TITLE 675 FIRE PREVENTION AND BUILDING SAFETY COMMISSION

Proposed Rule
LSA Document #19-330

Adds 675 IAC 14-4.4 setting minimum standards to govern construction of Class 2 structures. Repeals 675 IAC 14-4.3. Effective 30 days after filing with the Publisher.

Rule 4.4. Indiana Residential Code

FIGURE R502.8
CUTTING, NOTCHING, AND DRILLING

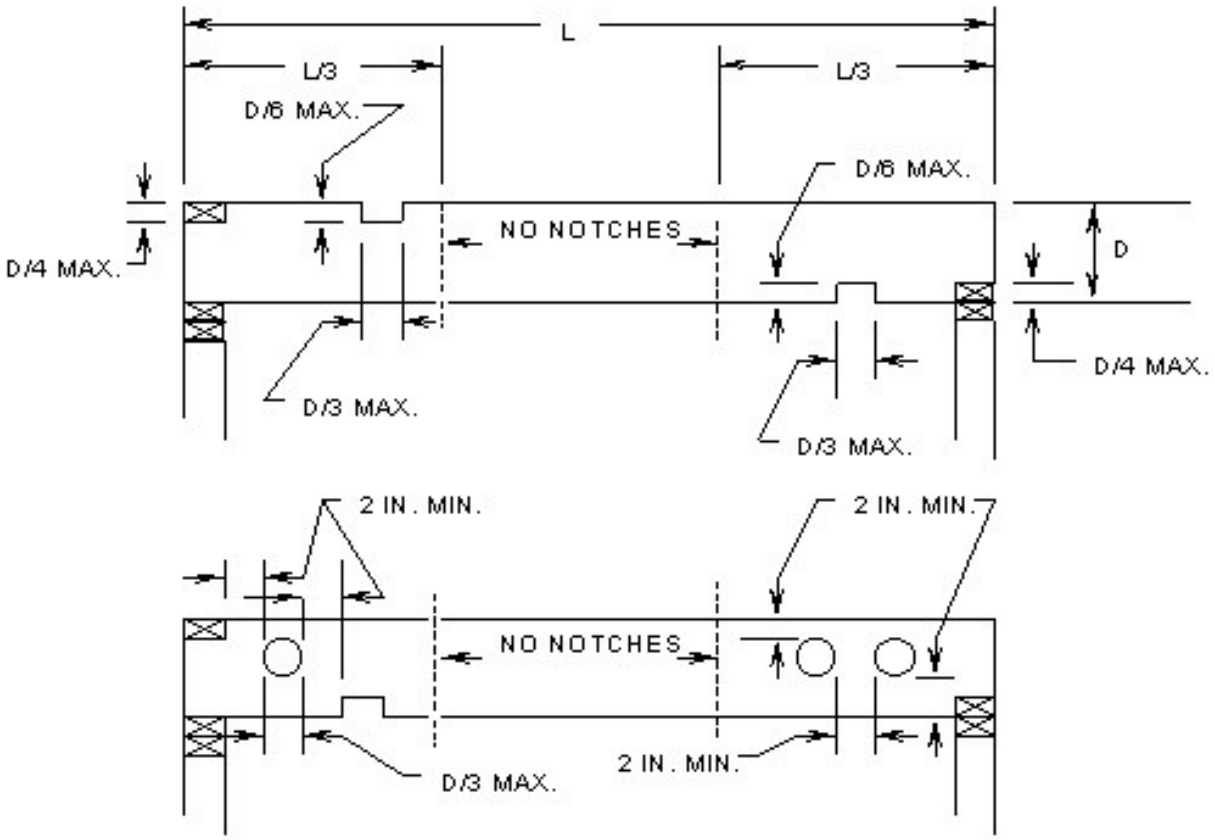
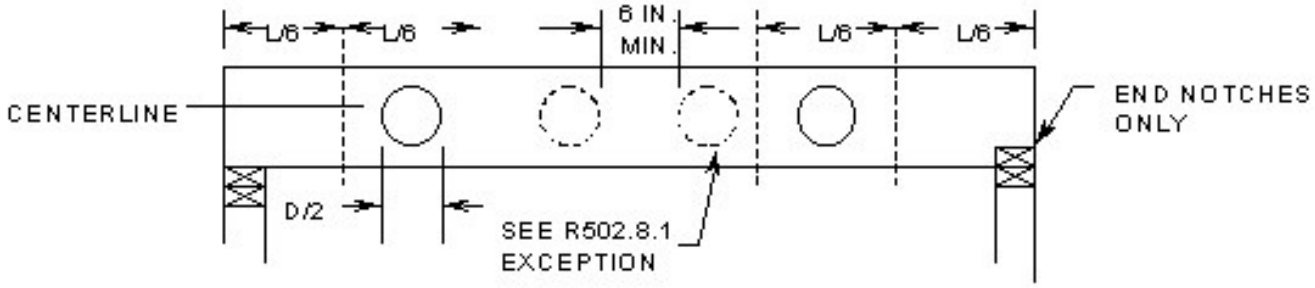
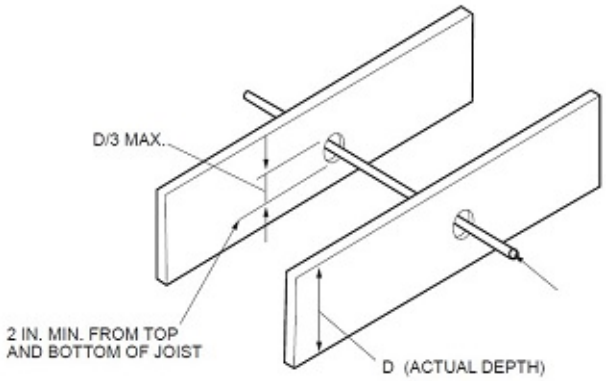
Sec. 59. Delete FIGURE R502.8 and substitute to read as follows: FIGURE R502.8:

Sec. 60. Add an EXCEPTION to the end of SECTION R502.8.1 to read as follows:
EXCEPTION: In 2 x 8 and larger solid lumber joists, holes up to 50 percent of the actual joist depth may be drilled at the center of the joist depth in the second and fifth sixths of the joist span. When the joist spans 90 percent or less of its maximum allowed span per Table R502.3.1(1) or R502.3.1(2), such holes may also be located in the center third of the joist span. Such hole shall be no closer than 6 inches (152 mm) from any other hole. Except for end notches, no notches may be in the same half of the span as a hole allowed by this exception.

FIGURE R703.7.6(1)

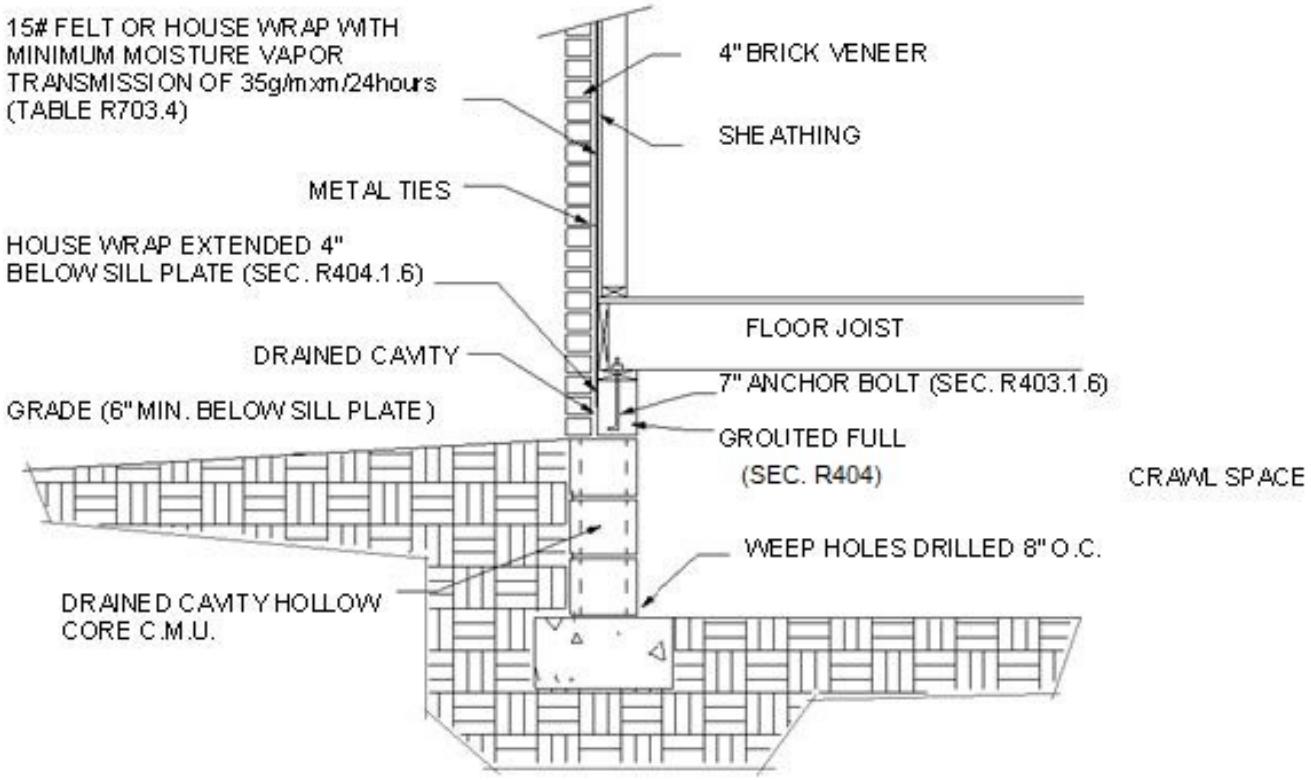
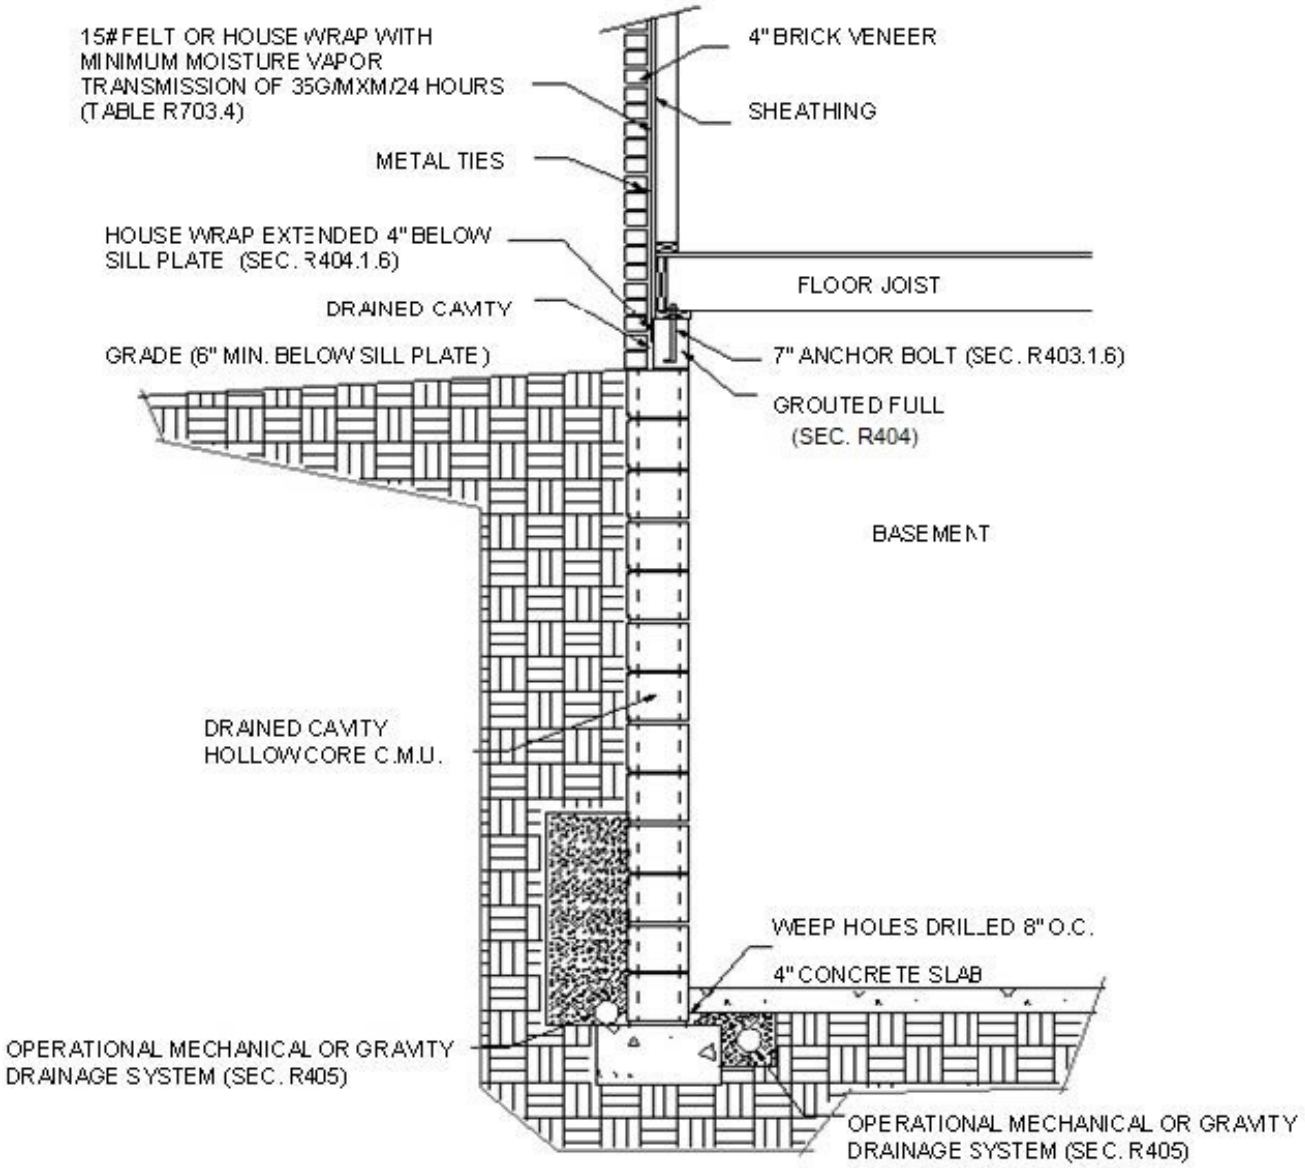
Sec. 78. Delete SECTION R703.8.6 in its entirety and substitute to read as follows:
SECTION R703.8.6 DRAINED CAVITY.
The 3/4 inch (19 mm) air cavity shall be drained to the exterior of the structure at intervals of not more than 33 inches (838 mm) on center. Each drain shall be not less than 3/16 inch (4.8 mm) in diameter, located immediately above the flashing. For dwellings with crawlspaces, the air cavity may be drained as shown in FIGURE R703.8.6(1). For dwellings with basements, the air cavity may be drained as shown in FIGURE R703.8.6(2).

FIGURE R1003.9 TERMINATION

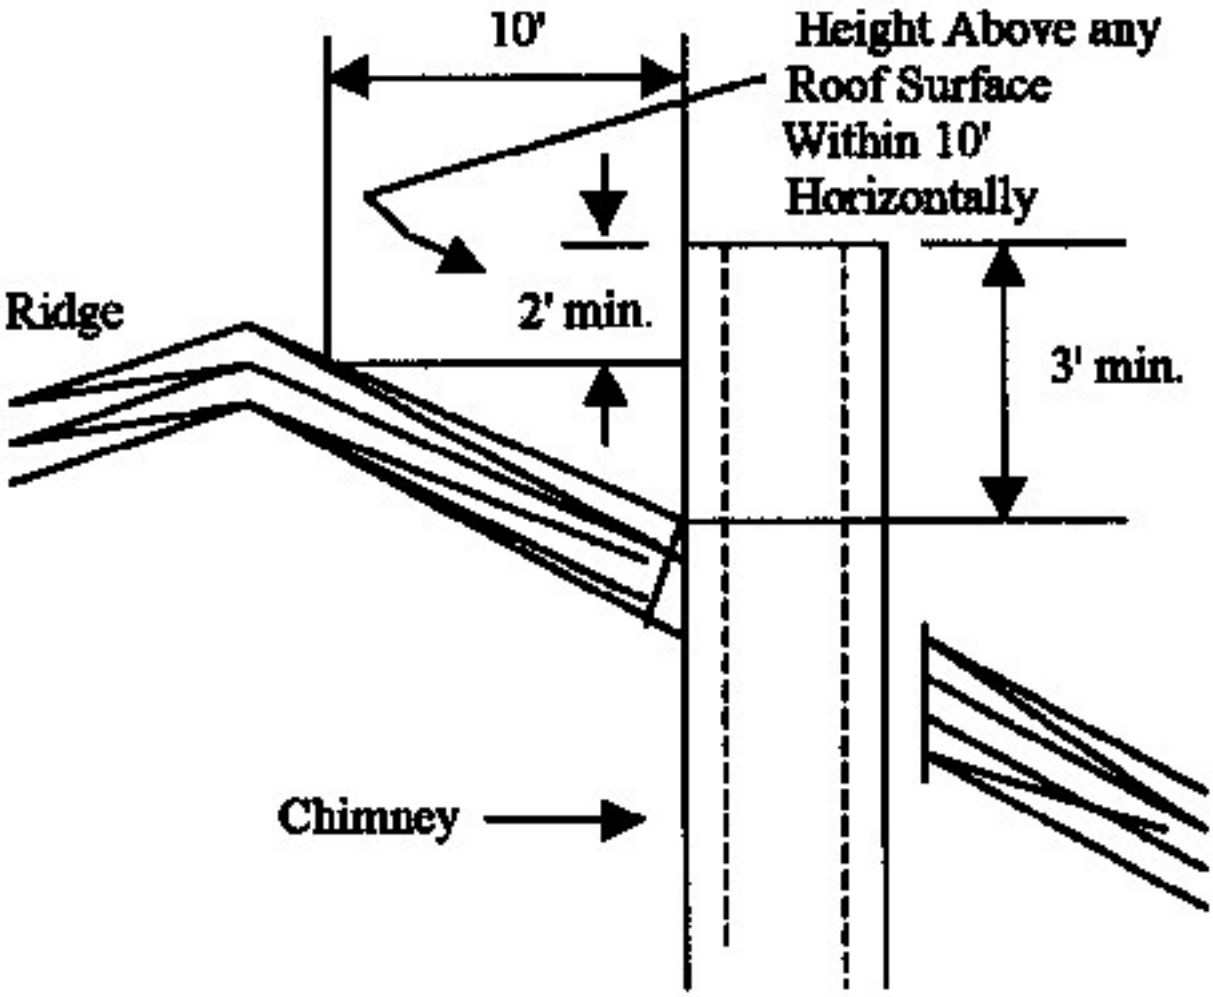
Sec. 87. Add FIGURE R1003.9 after SECTION R1003.9 as follows:
